MIL-C-60578(MU)
AMENDMENT 2
15 November 1973
SUPERSEDING
AMENDMENT 1
25 January 1973

MILITARY SPECIFICATION

CIRCUIT CARD ASSEMBLY - POWER SUPPLY, HUNDREDS DECADE
MATRIX AND READOUT - A3: 10547230

This amendment forms a part of Military Specification MIL-C-60578(MU) dated 18 June 1970.

FIGURE 2 TIMING CHART

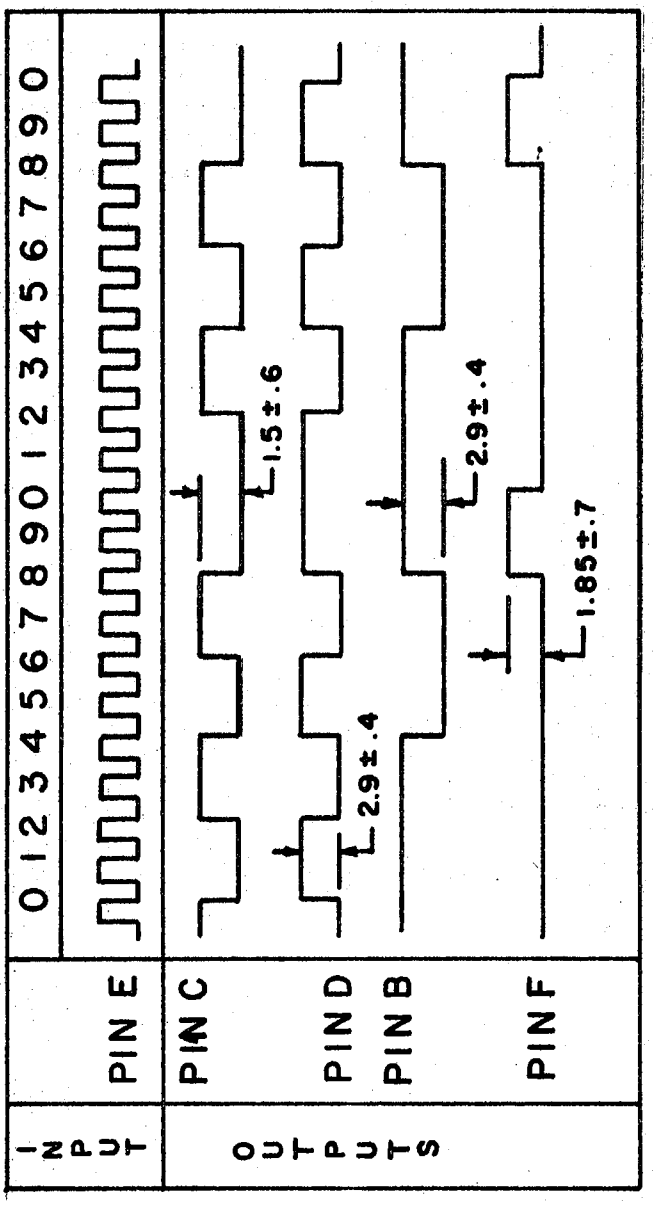
Figure 2: Delete and substitute:
